14-0911-1 – Battery Stud

Product Affected – Chassis Mounted Battery Box Stud

Fig 1

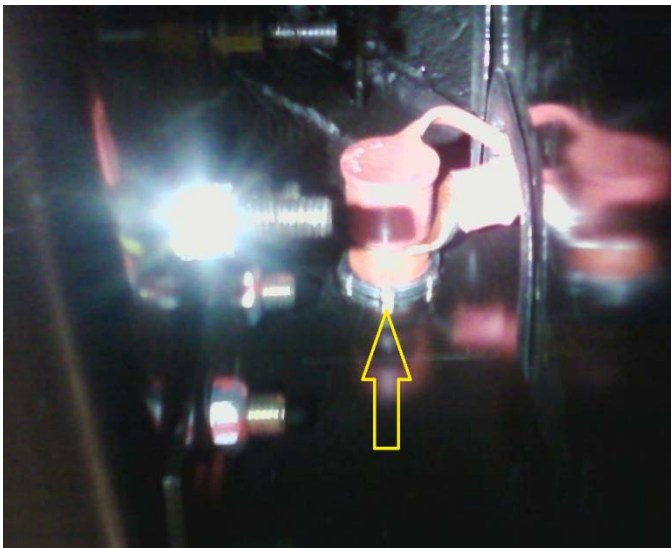
- Complaint:** When servicing the batteries, the power cable is “loose” where the cable goes through the back of the battery box.
- Cause:** There is a power stud mounted behind the battery box and with the battery tray moving in and out the pulling on the cable loosens the stud.

- Correction:** Figure #1 shows the stud mounted to the battery box and the spanner nut holding the stud to the box. Figure #2 shows the stud to the rear of the box. One thing we found is the spanner nut is located in such a position that it is difficult to get a spanner wrench or socket on it. If you disconnect the batteries, remove the cables and then remove the stud and re-install 180* so that the spanner nut is located to the rear you can get a better “grip” on it with your spanner wrench or socket. Adding a drop of Loctite will help ensure the stud will not loosen from future movement of the cables. See figures #3 and #4-
